Answers to the Request for Additional Information
DAHER NUCLEAR TECHNOLOGIES GmbH
Docket No. 71-9362
Model No. DN30 Package

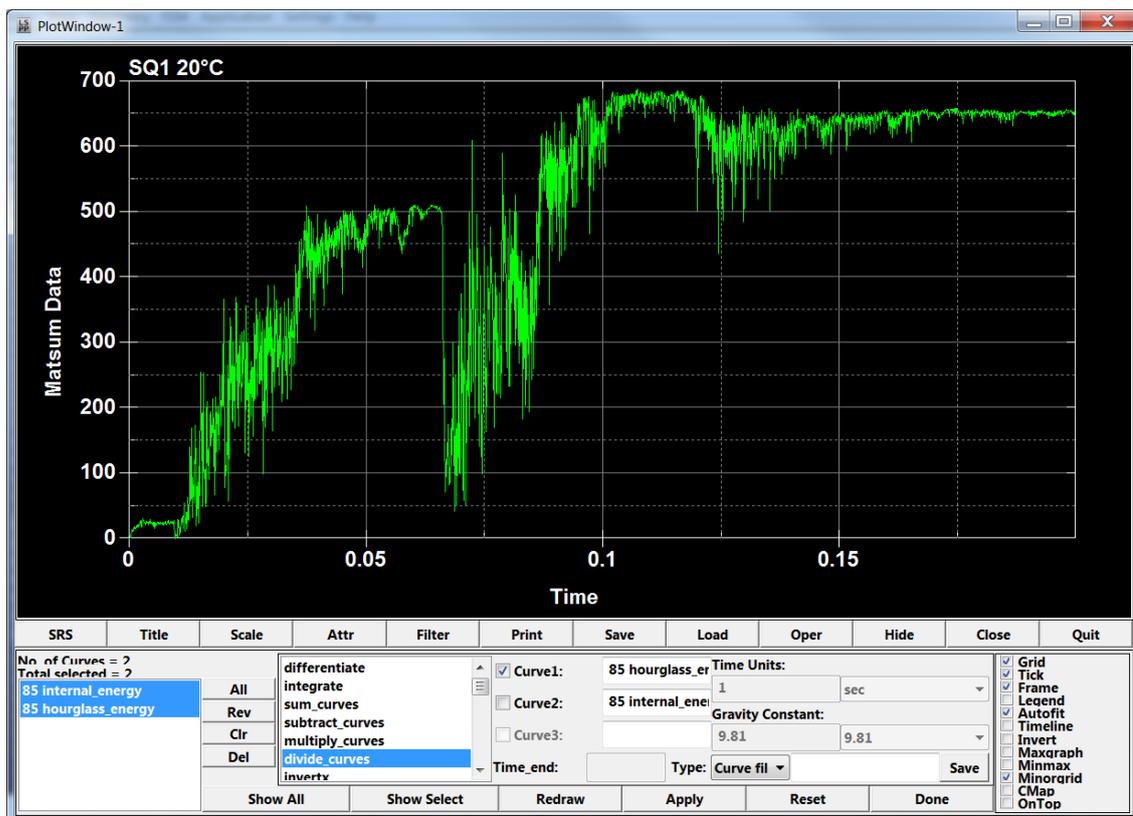
- b) The UF₆ material is modeled as one large piece during the drop simulations. Clarify if vibrations incident to transport could potentially “break up” or fracture the UF₆ material, prior to a drop. In such a case, large pieces of UF₆ should be modeled during drop simulations.

The assumptions used for the characterization of UF₆ with respect to the experimental drop tests and the drop test simulations are discussed in Chapter 2 of Technical Note 0023-BBR-2019-004-Rev1 (Attachment 1 of this document).

With regard to RAI 2-1 a), except for drop test sequence 4, the content is never bonded to the 30B cylinder. In drop test sequence 4 (flat drop onto the closure system) the content began to rotate inside the 30B cylinder, which introduced unrealistic rotational inertia into the system. This unrealistic behavior was identified by comparing the deceleration curves from the experiment and the simulation.

Lower filling ratios of the 30B cylinder below 50 %, that potentially allow more movement of the content inside the cylinder, are also covered by the current simulation model. A gap has been introduced between the cylinder shell and the content to avoid initial penetrations in the model. Combined with the content's deformation, large relative movements between the content and the 30B cylinder occur, which is clearly seen during the simulation of drop I in Sequence 8.

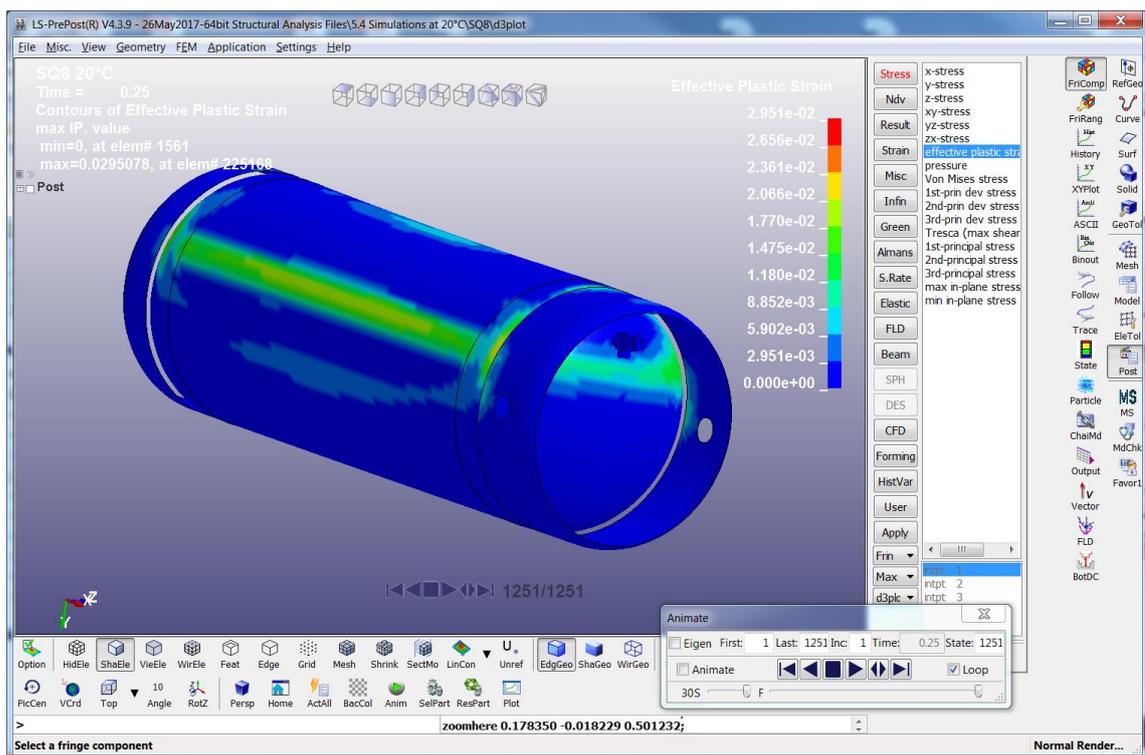
The image below displays the inelastic deformations observed in the 30B cylinder after Sequence 8 has terminated. The applicant states that a fine mesh would be required to model the welds between parts such as those in the 30B cylinder but would be too time consuming. Instead, tied contacts have been used. From the picture below, the canister appears to have inelastic deformations, in the main body of the cylinder, which do not carry at all into the adjoining/protruding flange which, if welded, should experience very similar inelastic demands where the 2 parts meet.

The parts appear to be too separated from each other and do not appear to be transmitting forces correctly. The valve at the end of the cylinder appears to be in a zone of inelastic deformation; yet, it is unclear how the valve behaves as a result. Staff is concerned that the containment boundary (valve) may not be free of inelastic deformation as desired. Similar behavior has been noted for the 30 B cylinder in other sequences.

The applicant shall verify that the tied contact assumption is valid when compared to welds that have been modeled as the rest of the 30B cylinder (with a mesh).

The results show that a continuous distribution of plastic strain can only be obtained with mesh connections or solid elements. However, the results also show that the better the representation of the actual connection is, the lower the resulting maximum plastic strain is. By using solid elements for the 30B cylinder, the plastic strain drops from 3.3 % obtained with the shell model to 1.9 %. Consequently, the maximum plastic strains obtained with the current FEM model in the SAR are conservative and no update of the FEM simulations is required.

completely filled 30B cylinders
(cut of the calculation model)

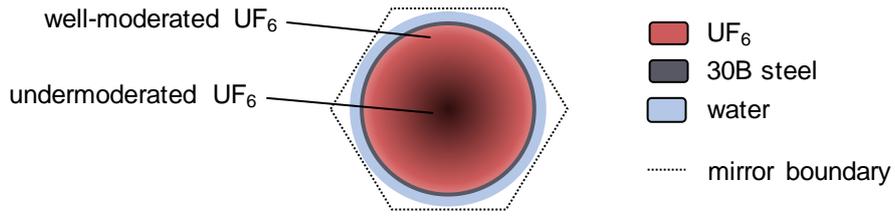
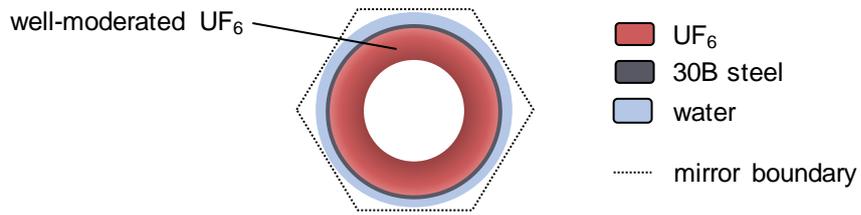
- 6.5 Clarify the most reactive UF₆ fill levels in the DN30 transportation package. Section 7.3.1 of Appendix 2.5.5, Rev.1 states that a completely filled 30B cylinder (i.e., 60.7%) is more reactive than a partially filled cylinder. Contrary to that statement, the calculation model in Section 7.3.2 indicates that the FILL2 configuration is more reactive than a completely filled cylinder, even though the quantity of UF₆ is less than the maximum allowable mass of 2277 kg of UF₆.

The statements about the most reactive UF₆ fill level in Sections 7.3.1 and 7.3.2 of Appendix 2.2.5, Rev.1 refer to different assumptions about the geometry of the UF₆ within the 30B cylinder, so there is no contradiction. Moreover, 'completely filled' here actually does not refer to a cylinder filled up to the limit of 60.7 %, but to a cylinder filled to 100 % with UF₆. This obviously overestimates the amount of fissile material that can be present in an actual DN30 package. Furthermore, all UF₆ filling states between 0 and 100 % are examined, so that there are no restrictions on the fill levels from the criticality safety analysis.

Since the statements about the optimal fill level are rather brief, some additional explanation will help to clarify: for the UF₆ geometry described in Section 7.3.1, called FILL1, the UF₆ is located in the lower part of the 30B cylinder, with a level surface between the UF₆ below and the empty cavity above. This level surface simply rises upwards as the fill level increases. For this geometry FILL1, the covering scenario is indeed a completely filled cylinder, as the calculation results in Section 8.5 for a single package and in Section 9.4 for an infinite package array show.

For the UF₆ geometry described in Section 7.3.2, called FILL2, the UF₆ is attached to the inner walls of the 30B cylinder, with a cylindrical empty space in the center for fill levels below 100 %. For this geometry FILL2, a completely filled cylinder is still the covering scenario for a single package in isolation, as the results in Section 8.6 show.

However, for an infinite package array with optimal moderation in the interstitial region between packages, lower fill grades can lead to the highest k_{eff} results (see Section 9.5). In this configuration, the fissions mostly occur in the well-moderated UF₆ region in close proximity to adjacent cylinders, meaning close to the inner cylinder wall. In completely filled cylinders, UF₆ located in the cylinder center is undermoderated and thus will not contribute a lot of fissions. It will, however, lead to absorption of some neutrons in the ²³⁸U content, thus decreasing reactivity.

Removing part of the undermoderated UF₆ from the center, i.e. going to fill grades below 100 %, increases the neutronic coupling between the optimally moderated UF₆ regions adjacent to the cylinder walls (see figure below) and will therefore increase the reactivity.
